Umbrellas on roof at 2 Fitzroy Street, Forrest

То	DA Taskforce, ACT Heritage Council
From	Kate Harrison, Conservation Officer, ACT Heritage
Subject	Alterations and additions at Block 8, Section 35, (2 Fitzroy Street) Forrest
Critical Date	5 July 2016

Proposed alterations and additions at 2 Fitzroy Street (Block 8 Section 35) Forrest

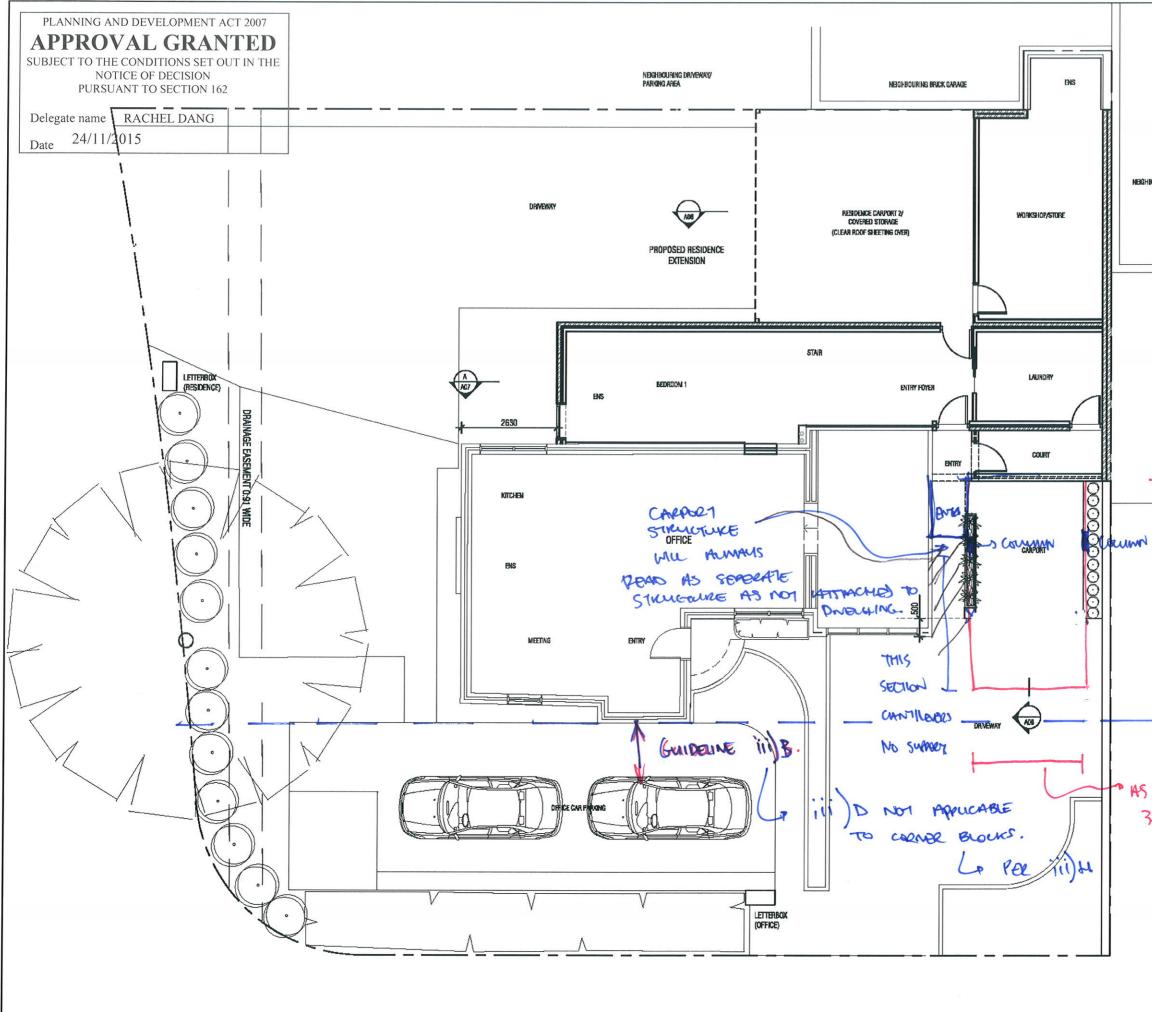
The Council considers that the umbrellas are not consistent with this requirement as they appear as a contemporary structure and their presence interrupts the pattern of the dwelling and its cubiform two storey form in the streetscape.

The umbrellas are considerably taller than the roof top of the existing dwelling, presenting an equivalent height of a third storey to the building; are highly visible; and detract from the original cubiform two storey form of the building.

The Council considers that the umbrellas and support post diminish the significance of the place and requests that they be removed by 6 May 2016. If this matter is not resolved by this date it may be escalated for further action.

The umbrella post is not fixed to the roof of the dwelling as it is weighted down by existing planter boxes on the roof. The Council acknowledges that the umbrellas will not be erected on a permanent basis, are not attached to the building; and therefore does not object to the retention of the umbrellas on the roof.

GROUND FLOOR PLAN

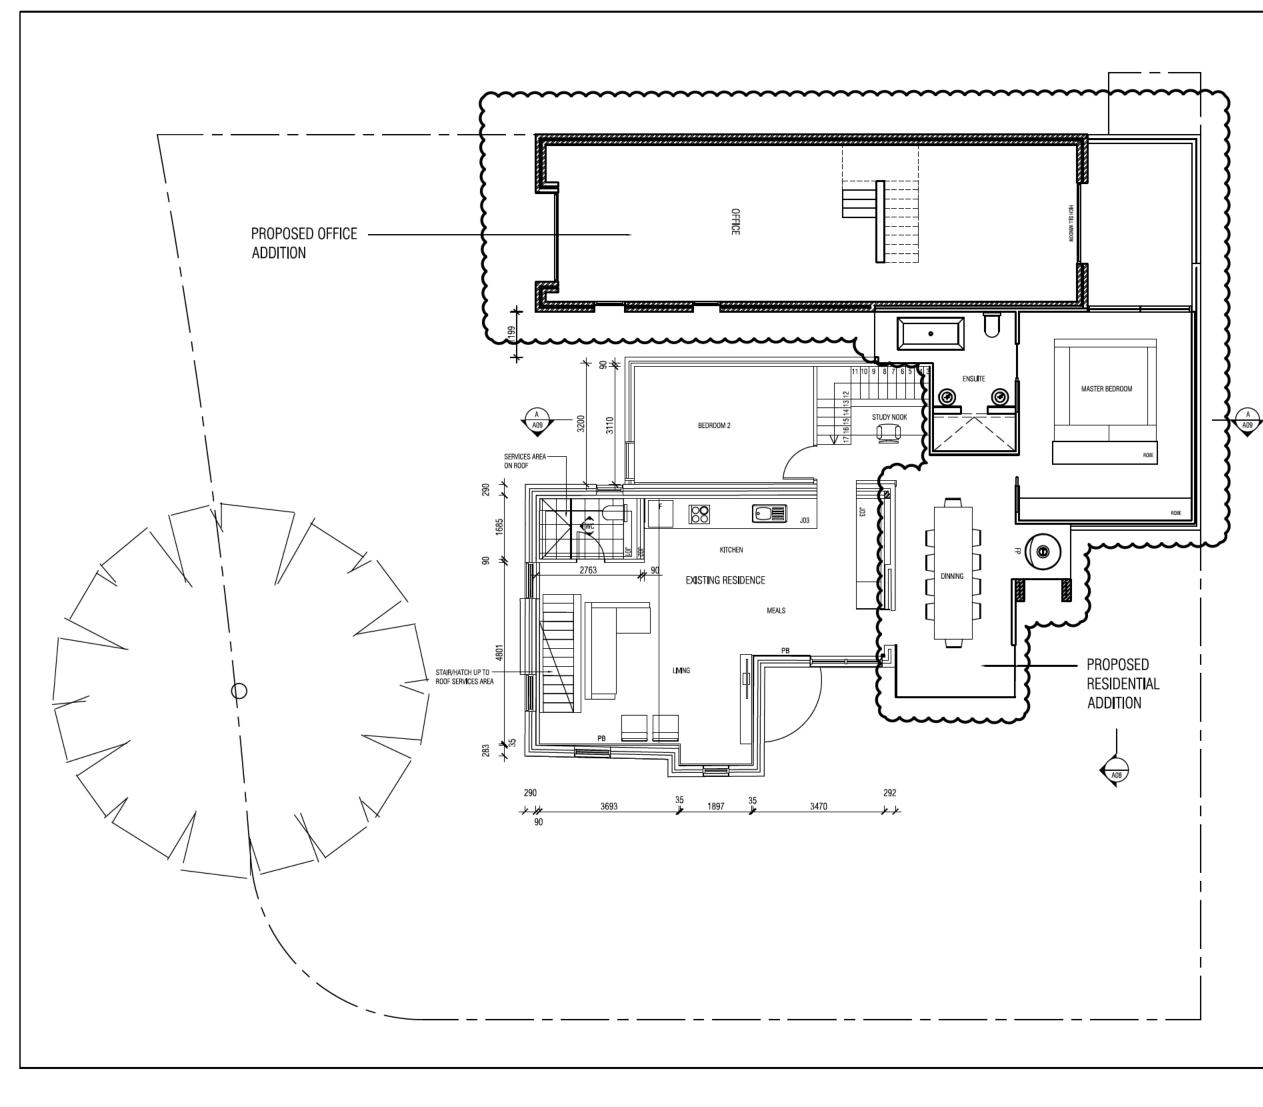
- Part ii)a) of the guidelines stipulates: 'the original existing external appearance of the buildings including ...original balustrades over balconies and incorporated garages...are to be conserved'.
 - The proposed side addition does not facilitate retention of the original balustrade over the garage.
 - The proposed side addition would enclose an original roof top balcony, a key characteristic of the Forest Fire Station residences. This change would not conserve the original existing external appearance of the building.
 - The Council has previously supported the installation of planter boxes on the

roof top of the building. However, the plantings illustrated appear to be substantial creepers, which may cause damage to the original brick work and would modify the original existing external appearance of the building.

- Part iii)e)of the guidelines stipulates: 'The original building form is to remain dominant'. As viewed from Manuka Circle, the bulk of the existing addition and new addition may dominate the original building form.

- Part iii)f) of the guidelines stipulates: 'The roof pitch, walls, materials, window types and materials, shall be as similar to the existing dwellings as is feasible'. The proposed side elevation would include an area of solid glazing highly visible from the street. This window type is not similar to the existing window type.

- The proposed glazed addition above the original garage is too dominant in form and character. The addition should be setback from the front face of the nearest original masonry facade. Setback behind the existing door is preferred. A drawing illustrating the proposed northern elevation should also be provided to demonstrate how the proposed addition will read in the surrounding context.

- Brick corbelling (to match the existing brick on flat/header course) should be used to delineate between the ground and first floor levels on the Fitzroy Street and Northern elevations.

- Details of the proposed plant species for the roof top planters have not been provided. To ensure compliance with Part ii)a) of the heritage guidelines, a species that does not cause damage to the brickwork should be nominated.
